BIDS AND AWARDS COMMITTEE
INFRASTRUCTURE & REPAIRS

Bid Bulletin No. 5
REPLY TO QUERIES/CLARIFICATIONS BY THE BIDDERS

This Supplemental/ Bid Bulletin no. 5 dated January 31, 2022 for the project: **“CONSTRUCTION OF FIVE-STOREY RESOURCE MANAGEMENT BUILDING- PHASE 2 (INFRA-2022-01)”**, is issued to modify or amend items in the Bid Document, and to address queries/ clarifications sent by the bidders through e-mail in compliance with Section 25.5.1 of the 2016 Revised IRR of RA 9184.

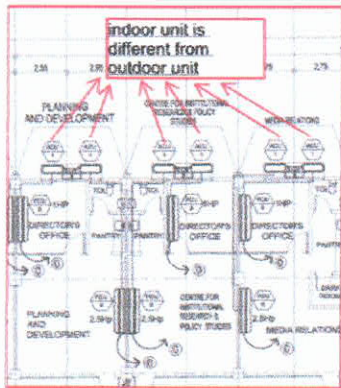
| Query | QUERIES/CLARIFICATIONS | ANSWER |
|-------|--|---|
| 1 | <p>Mechanical Works</p> <p>Please clarify:</p> <p>Some equipment in the layout is not in equipment schedule. Also some quantity of the equipment in is inconsistent between the layout and the equipment schedule. Refer to the below example:</p> <p>Reference: Dwg. M-01 to M-05</p> | <p><u>Item A. GENERAL REQUIREMENTS - Design Consultancy (Electrical, ECE, Auxiliary, Fire Protection, Aircon System, Plumbing / Sanitary) is included in the Scope.</u></p> <p><u>BulSU provided the draft design for MEFPS works. Particularly for AirCon System of the building, BulSU indicated in the drawings initial layout for ACU requirement of each rooms. The winning bidder's Professional Mechanical Engineer shall finalize the design in coordination with BulSU counterparts. The winning bidder shall issue the drawings, specifications, and other related design</u></p> |

documents signed by the Professional Mechanical Engineer as part of the Design Consultancy Scope.

However, roughing-ins for Aircon system includes pipe sleeves in slabs if necessary; Supply of Aircon units is not included in this Scope.

Please note that this scheme holds true with all MEFPS and Auxiliary works Design Consultancy scope.
